# **MAC/PHY Delay Variability: Corner Cases and Solutions**

- An action item from September meeting required to verify the PHY Delay Variability through simulation and to report the results back to TF in November (see comment 2414)
- In simulation, three corner cases were identified that cause increased delay variability
  - Case 1:** Deficit Idle Counter changes FEC codeword boundary
  - Case 2:** Under light load, a frame arrives between column boundaries
  - Case 3:** Under light load, a frame arrives during parity block

- OLT Control Multiplexor (Figure 77-13) →

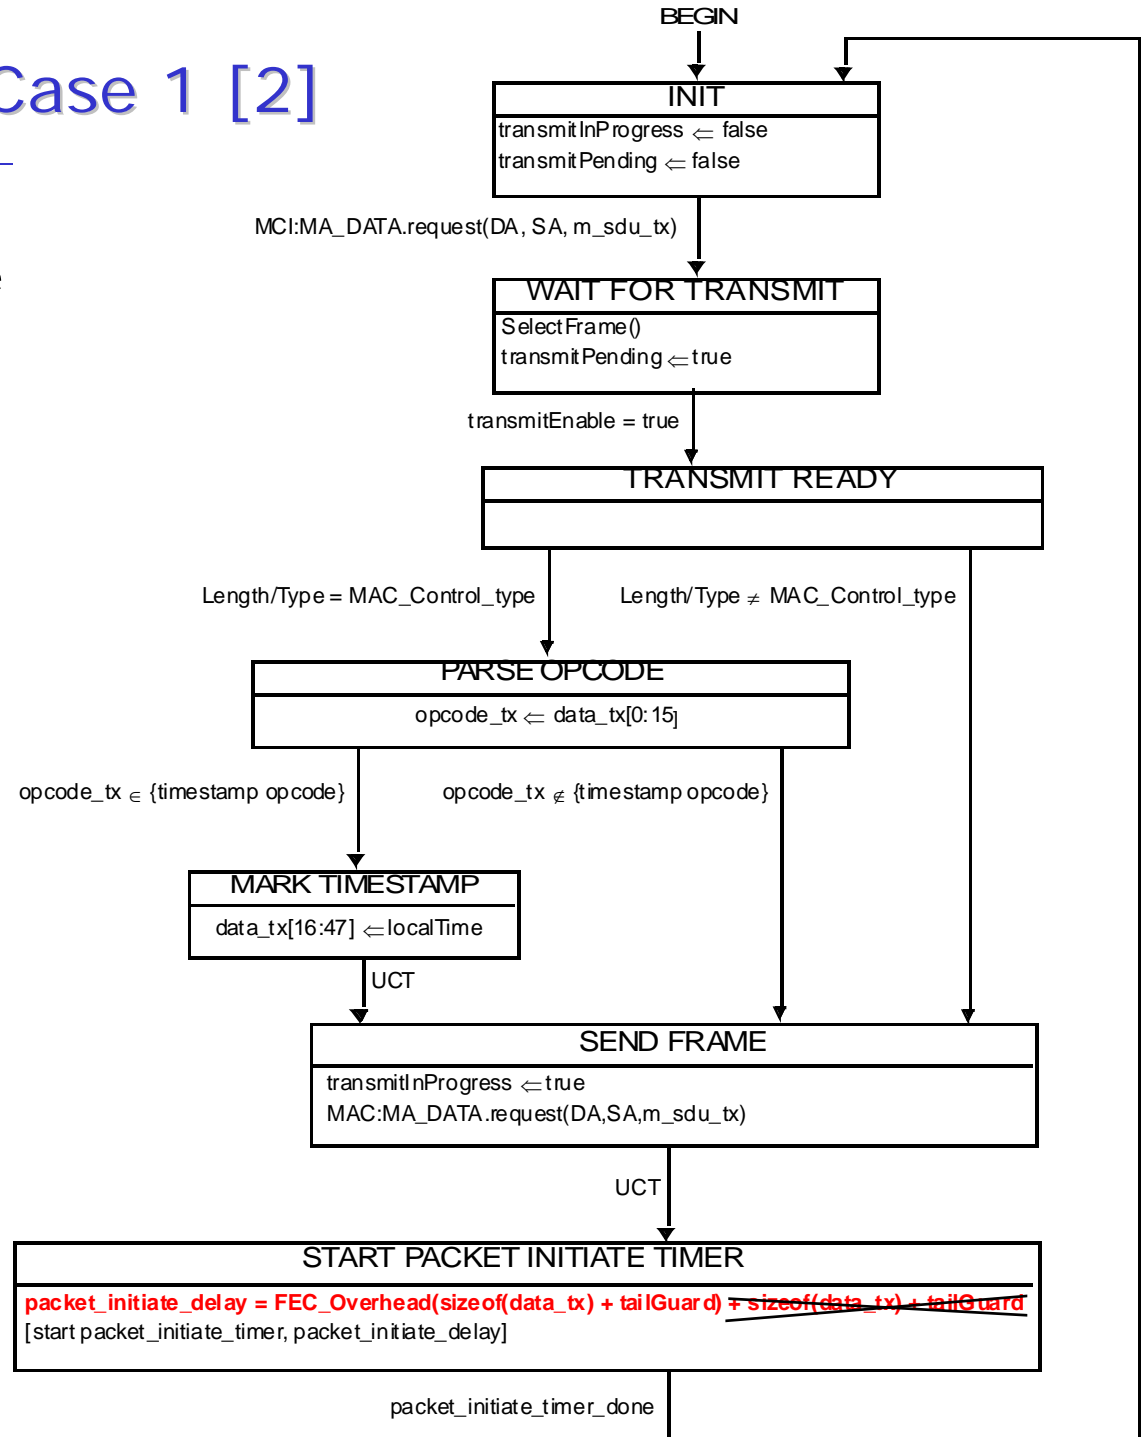
- In state START PACKET INITIATE TIMER, replace

$$\text{packet\_initiate\_delay} = \text{FEC\_Overhead}(\text{sizeof}(\text{data\_tx}) + \text{tailGuard}) + \text{sizeof}(\text{data\_tx}) + \text{tailGuard}$$

with

$$\text{packet\_initiate\_delay} = \text{FEC\_Overhead}(\text{sizeof}(\text{data\_tx}) + \text{tailGuard})$$

- OLT Control Multiplexor (Figure 77-13) →

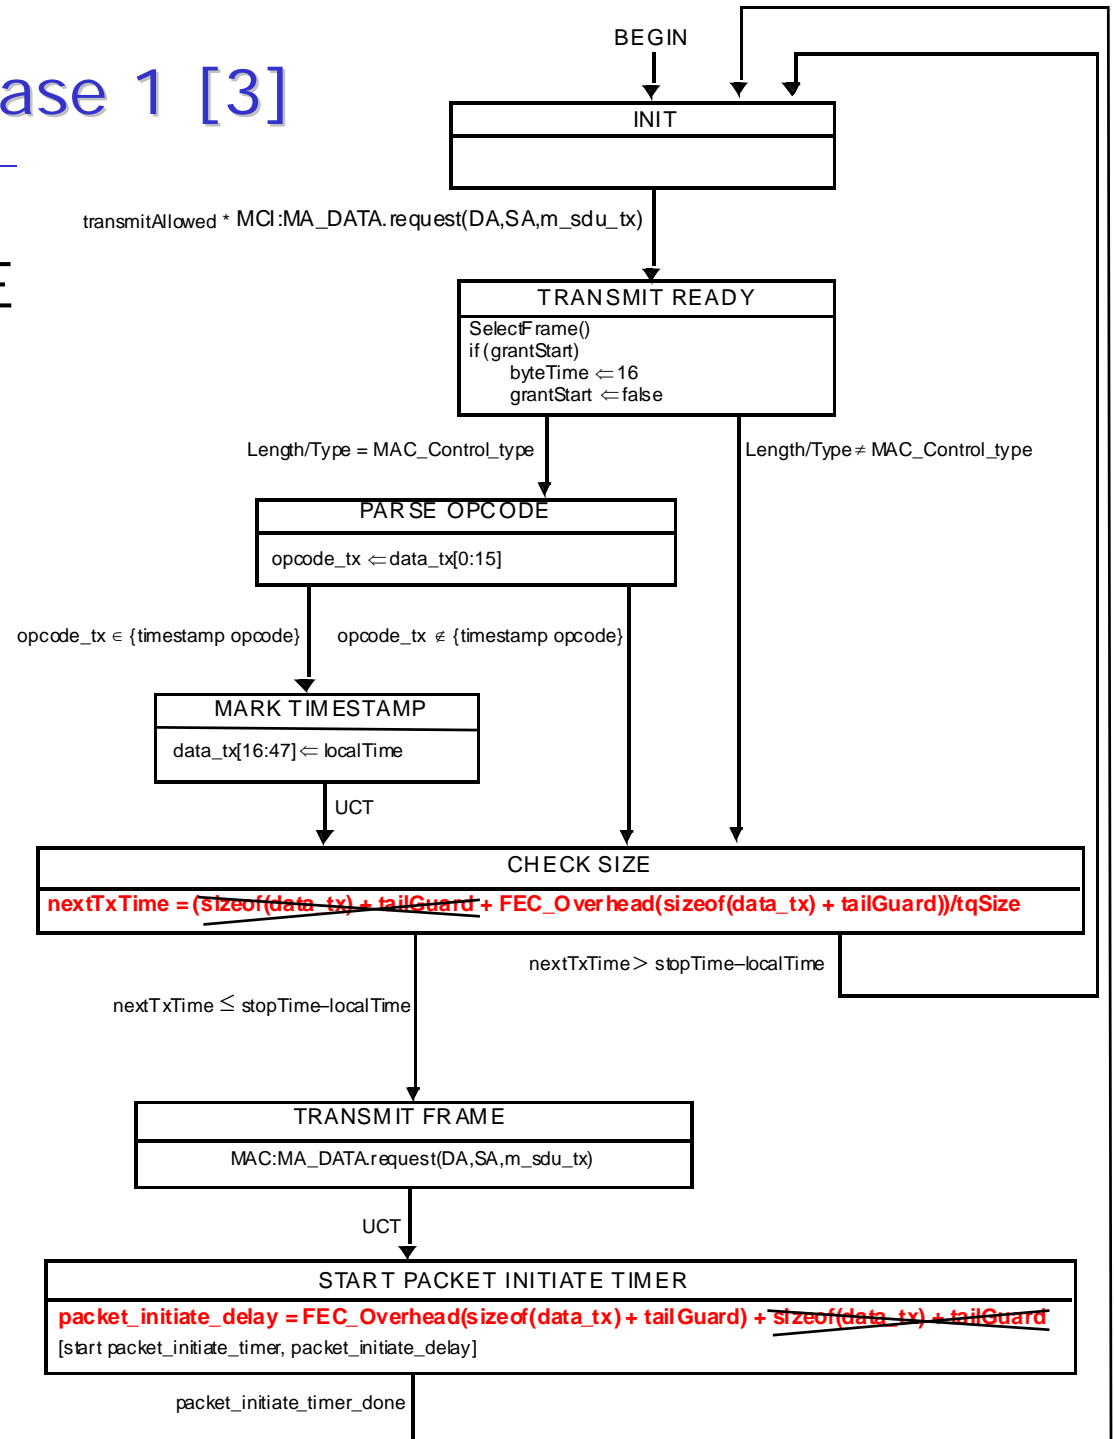
- In states CHECK SIZE and START PACKET INITIATE TIMER, delete

$\text{sizeof}(\text{data\_tx}) + \text{tailGuard}$

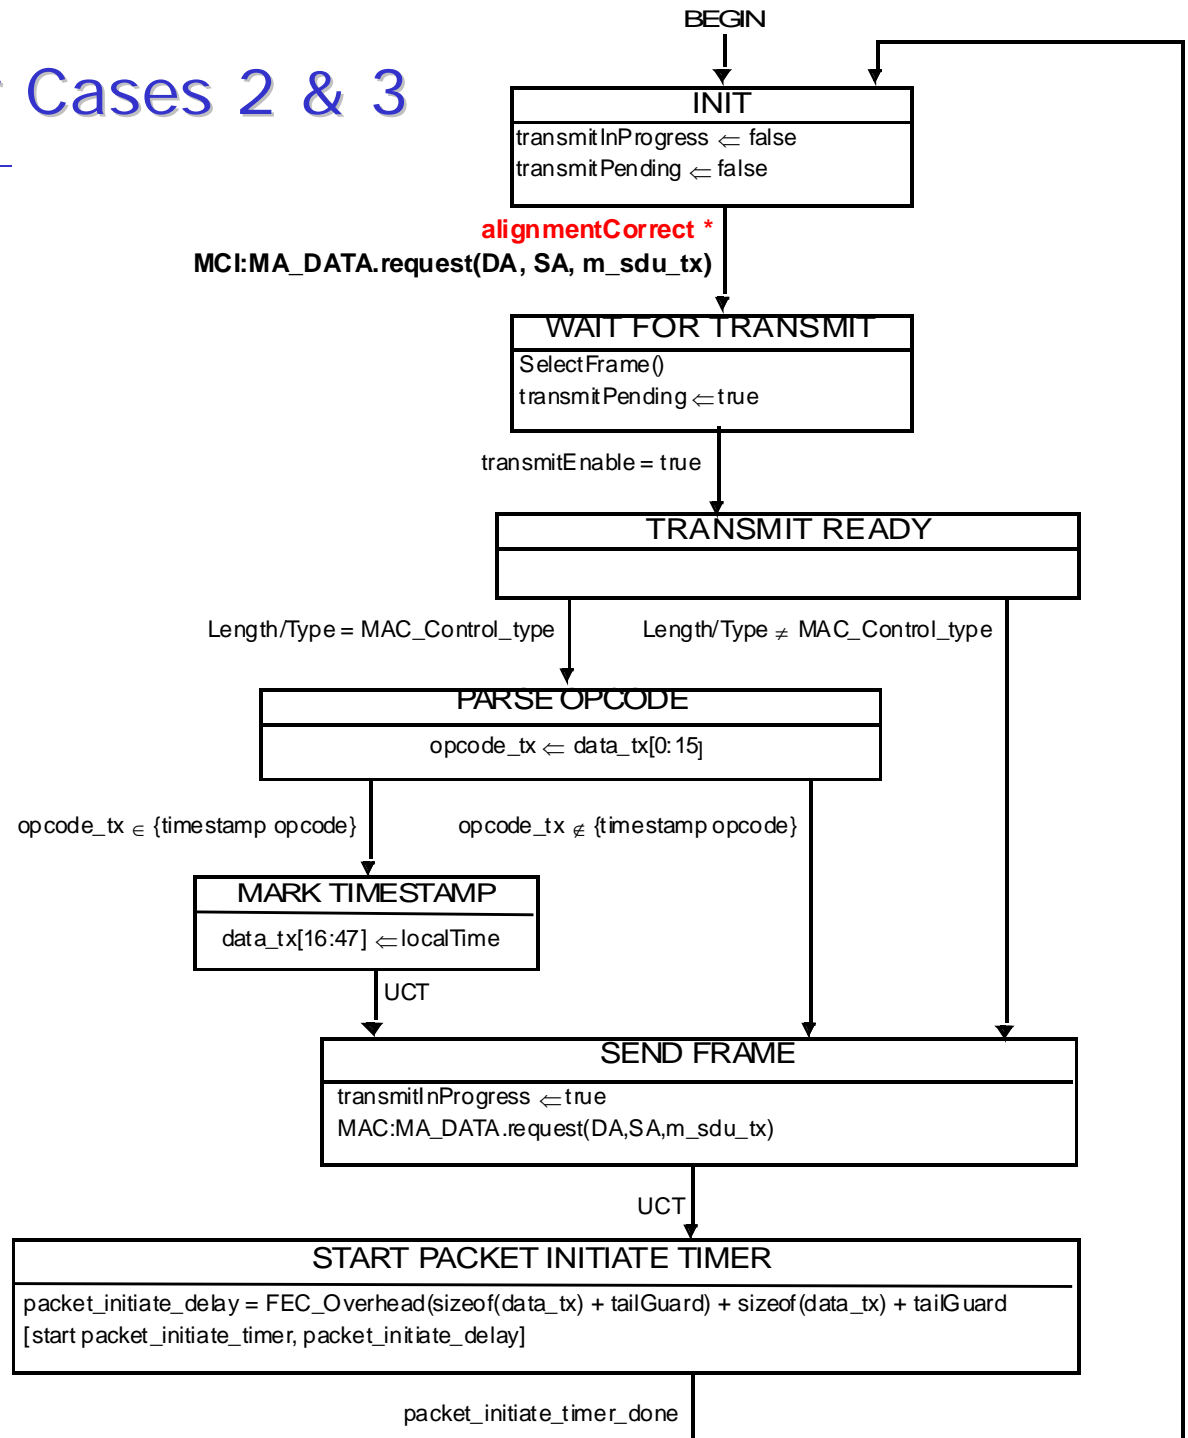
- Modify transition from INIT to WAIT TO TRANSMIT to allow frames through only
  - On column boundary and
  - During payload portion of FEC codeword.
- MAC Control frames that arrive during the parity portion will be delayed **before timestamping** until the parity part completes and column boundary is aligned.
- OLT Control Multiplexor (Figure 77-13) →

- ONU Control Multiplexor (Figure 77-14) →**

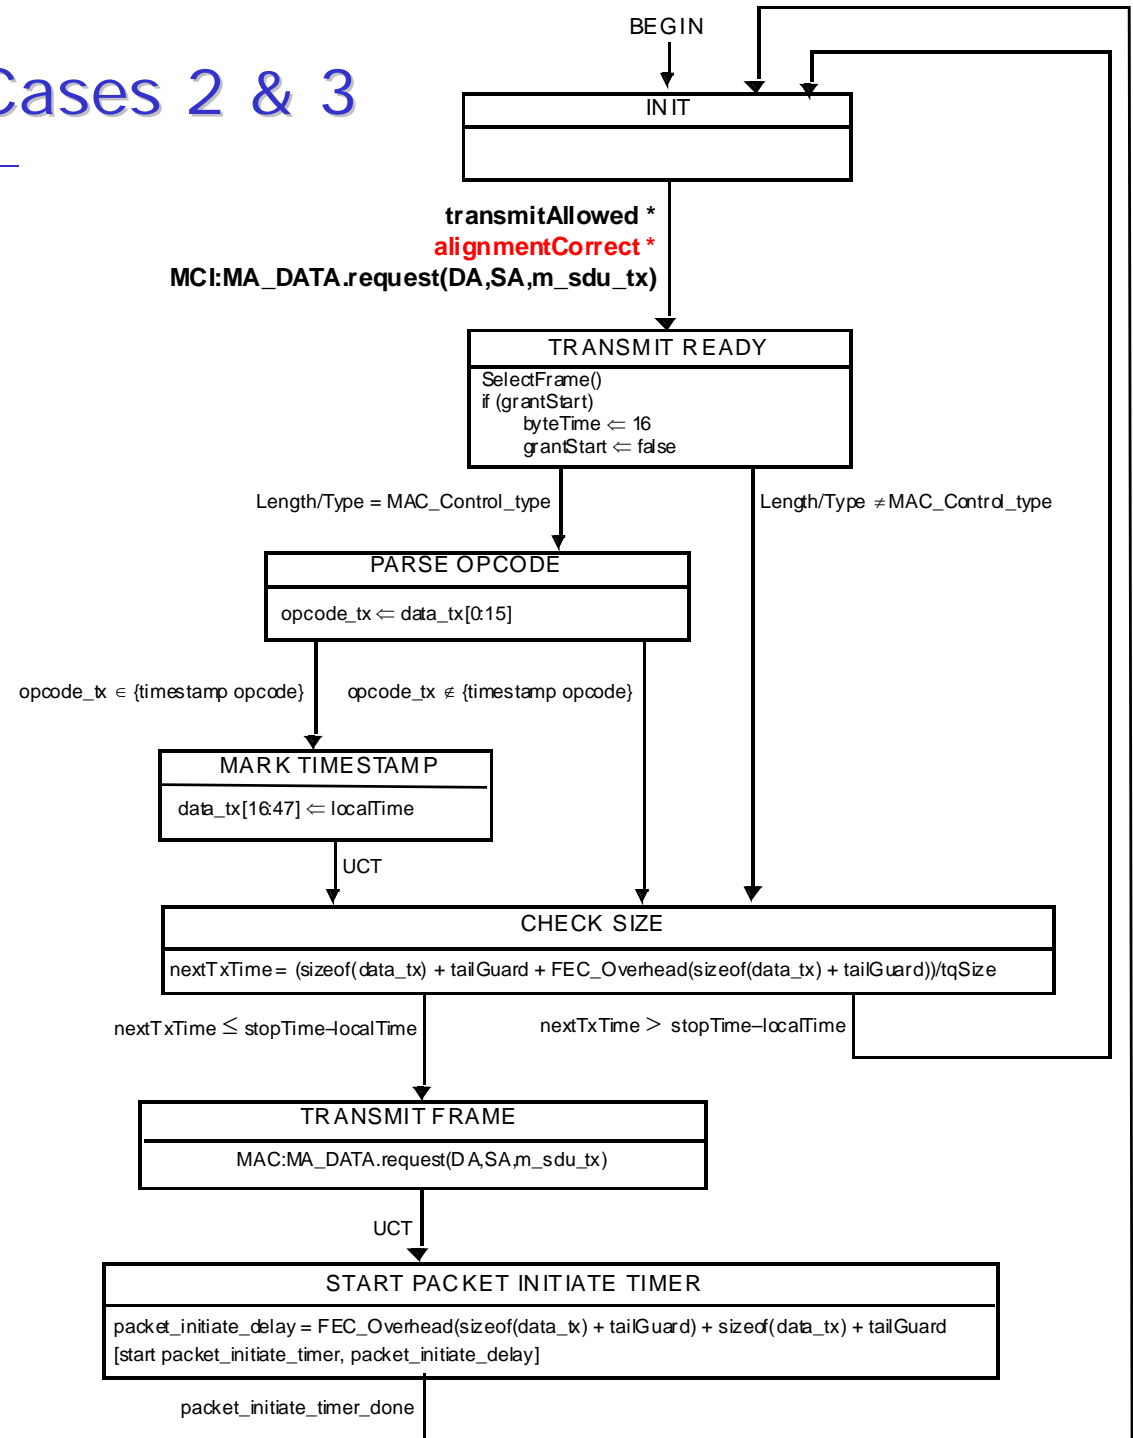
- Similar modification should be made to ONU Control Multiplexor.
